# UNITED STATES PATENT AND TRADEMARK OFFICE

10/083,093

## Office Action Summary

## **DETAILED ACTION**

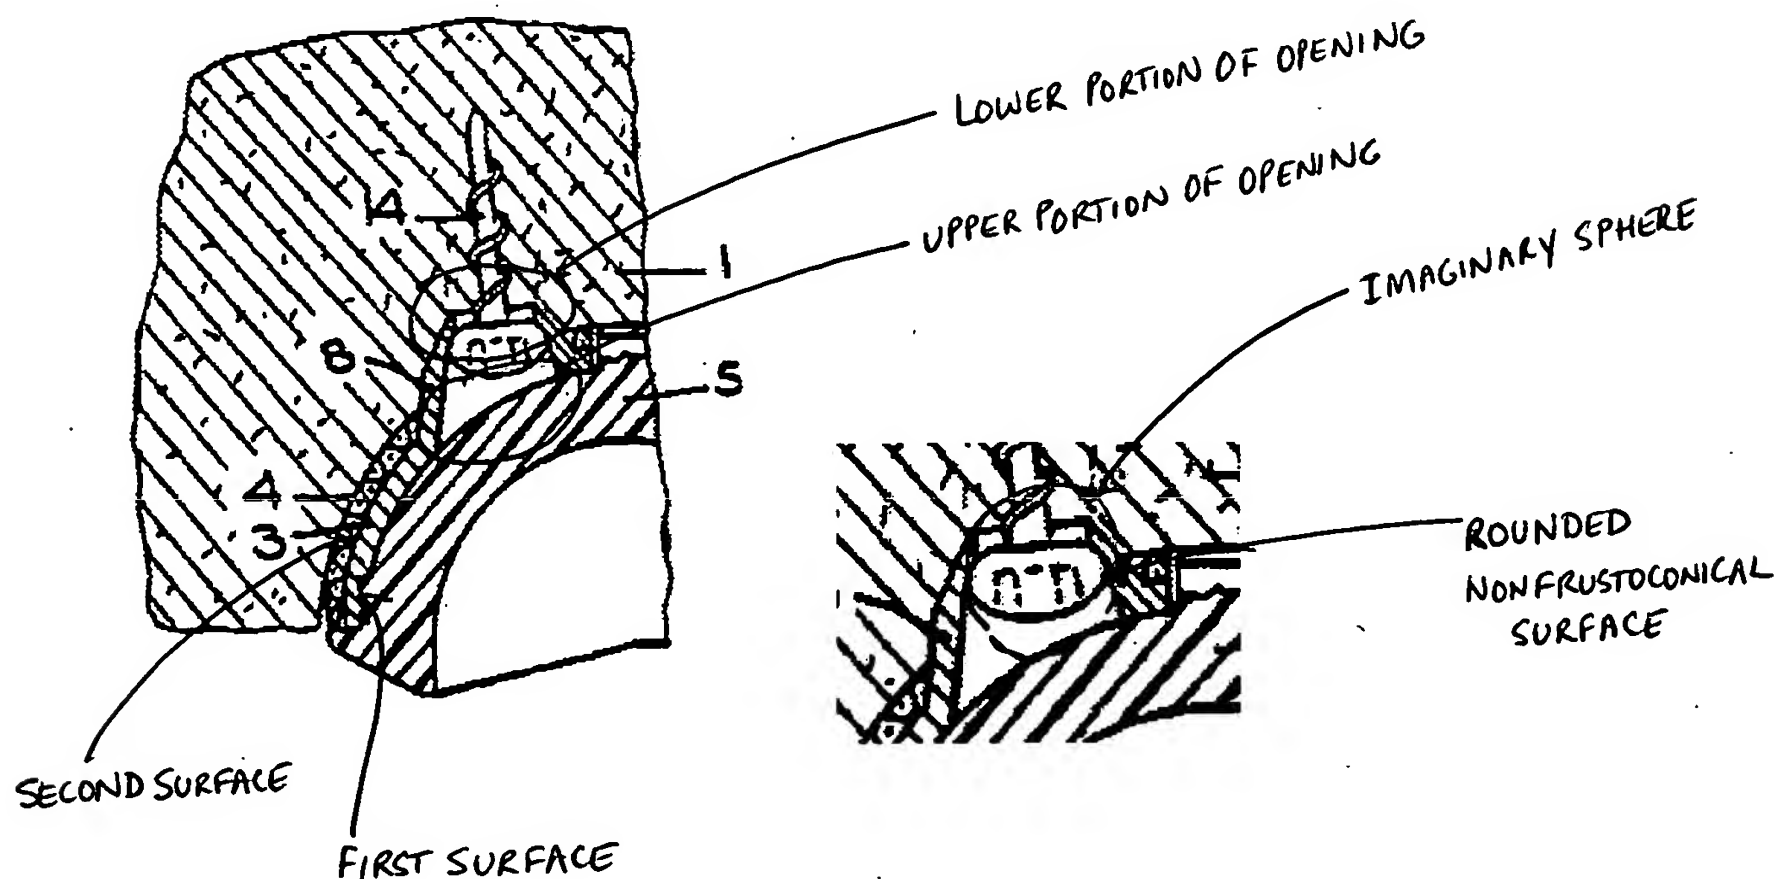
Marchetti et al. disclose an implantable prosthesis including: a metal shell or "prosthetic component" 3; at least one opening extending from a first surface to the second surface of component 3, the opening having a nonthreaded frustoconical upper portion and a lower portion; a screw or "insertion member" 14 with a rounded non-frustoconical contact surface that contacts the frustoconical taper section of the opening

and does not contact the lower portion of the opening (Fig. 4, col. 2, lines 39-68 and col. 3, lines 1-44). See marked up Fig. 4 from Marchetti et al. below.

Regarding the limitation, "in a substantially fluid tight relationship" it is noted that the head of screw 14 forms a seal by the head of the screw abutting against the conical surface of the opening. Turning to Applicants' specification to determine what constitutes a "substantially fluid-tight seal," at page 23, line 21 and page 24, lines 1-2, Applicants' disclose that a head of an insertion member should be received and locked in a screw hole to provide "at least a partial seal." The screw 14 of Marchetti et al. forms "at least a partial seal" by being received and locked in the opening and thus fits in the opening in a "substantially fluid tight" relationship.

Regarding claims 6, 35 and 42, the rounded surface of the head of insertion member 14 is part of a sphere or "imaginary sphere" as shown in marked up Fig. 4 below.

Regarding claim 7, once inserted into the opening and locked against the inner wall of the opening, the head of screw 14 maintains a constant point of contact with the inner wall, i.e., is locked in one position with respect to the wall.

Regarding claim 37, it is noted that the head of screw 14 abuts on the conical inner wall and thus provides a liquid-tight seal in that there is no opening or gap at the locking interface.

**Fig. 7**

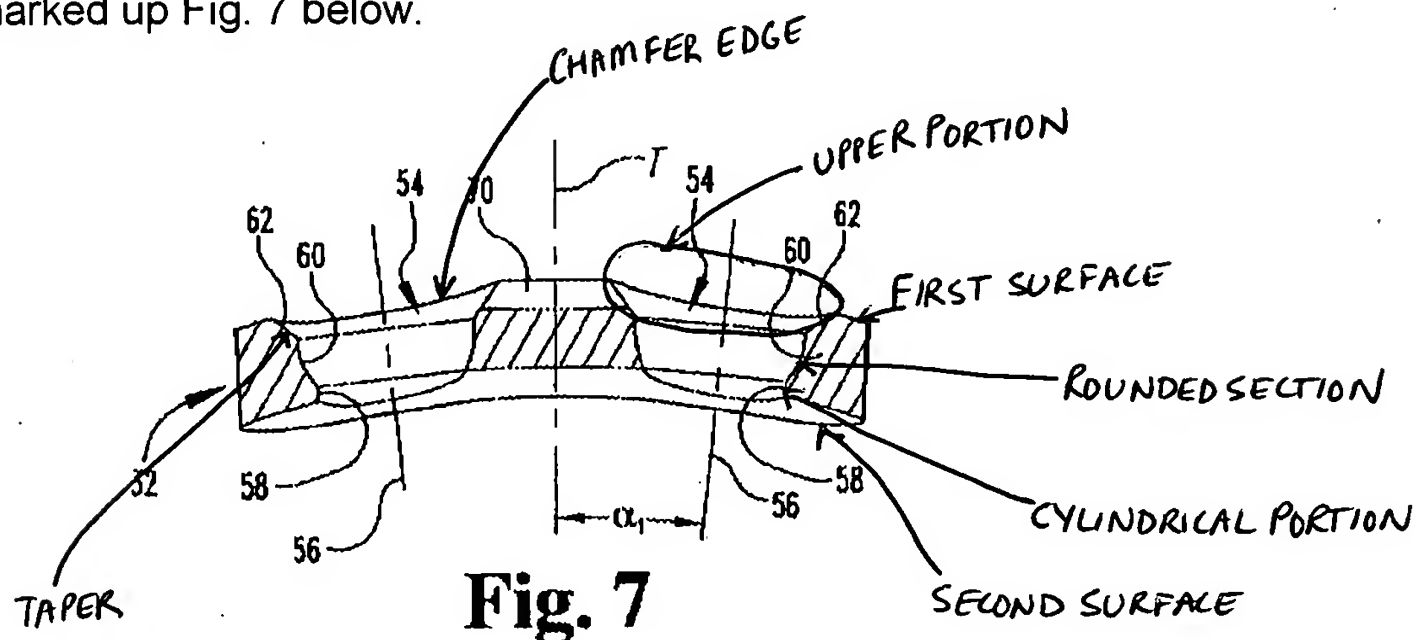
Justis et al. disclose a device or "implantable prosthesis" 20 including: a prosthetic component 22 having first and second surfaces; at least one opening 54 extending from the first surface to the second surface; each opening 54 further including a chamfer edge, an upper portion with a taper, a rounded section and a cylindrical portion; and wherein the rounded section has a smaller diameter than the conical taper

(Figs. 1, 7 and 8, col. 4, lines 31-45, col. 5, lines 26-49 and col. 8, lines 33-58). See marked up Fig. 7 below.

It is noted that the upper portion extends through a large part of the thickness of the plate and thus meets the limitation, "substantial portion" of the opening.

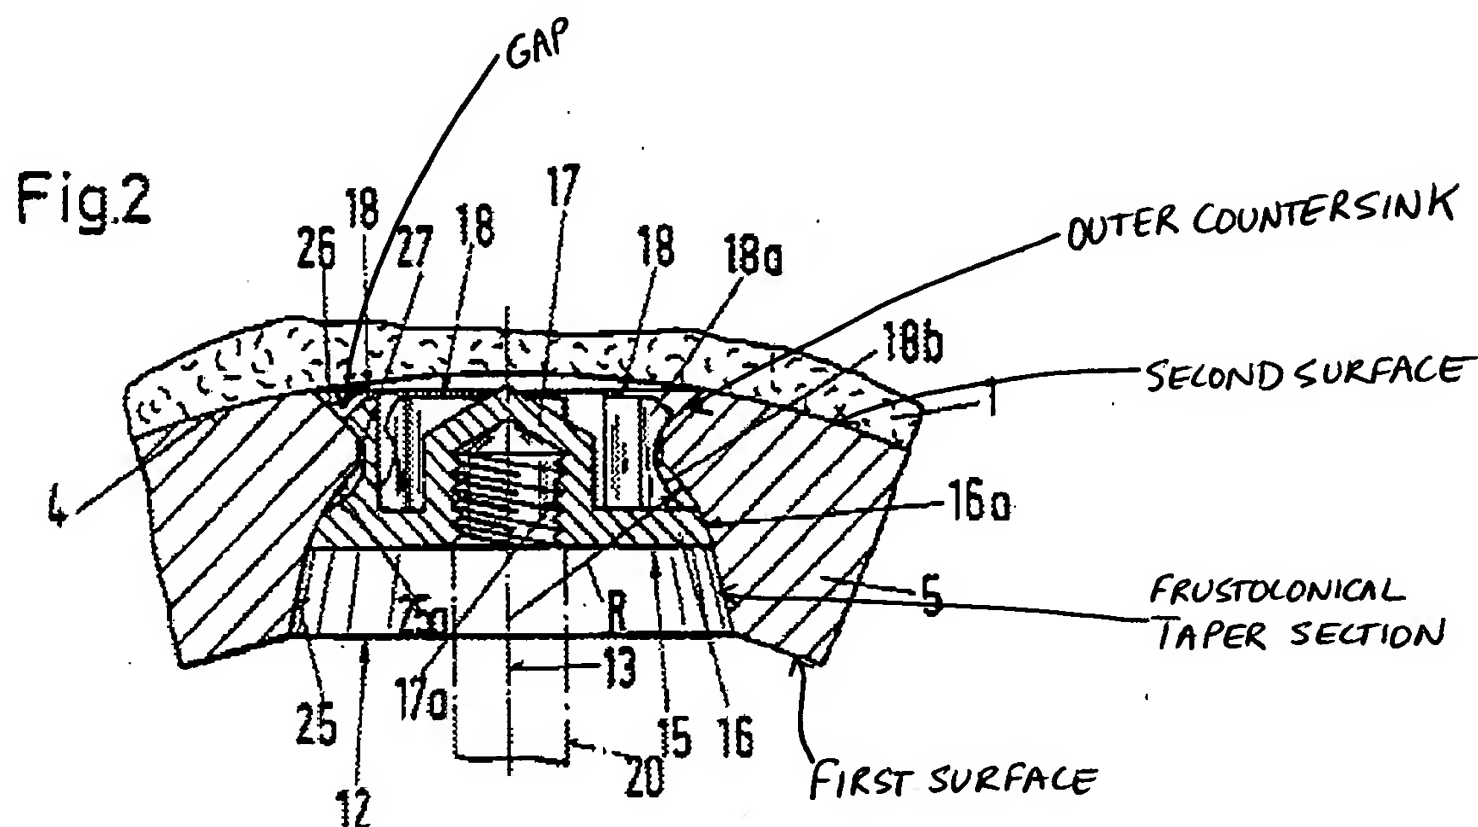
The Examiner notes that Oehy et al. clearly disclose that opening 12 receives a screw 14 and permits angular positioning of screw 14 in opening 12 (Fig. 2, col. 2, lines 54-65 and col. 3, lines 10-18). It is the Examiner's position that depending on the angular position of screw 14 in opening 12, the spherical surface 14a of the screw head would contact and be locked relative to frustoconical surface 25 in a manner similar to

Applicants' invention (Fig. 5). Further, head 14a does not contact the lower portion, namely, outer countersink 26. See marked up Fig. 2 from Oehy et al. below.

On page 20, Applicants' argue that Oehy et al. does not disclose "a gap between the second surface of the prosthetic component and a bottom of the insertion member head." It is the Examiner's position that there is a gap due to the outer counter-sink 26.

On page 20, Applicants' further argue that the Oehy et al. reference does not show or describe an insertion member with a "rounded, nonfrustoconical contact surface that contacts the frustoconical taper of the opening when locked relative to the frustoconical taper." As discussed above, in one of the plurality of angular positions of screw 14 in opening 12, the rounded surface of head 14a of insertion member 14 would contact frustoconical surface 25 and rounded portion 25a, in a manner similar to the configuration of Fig. 5 of Applicants' invention.
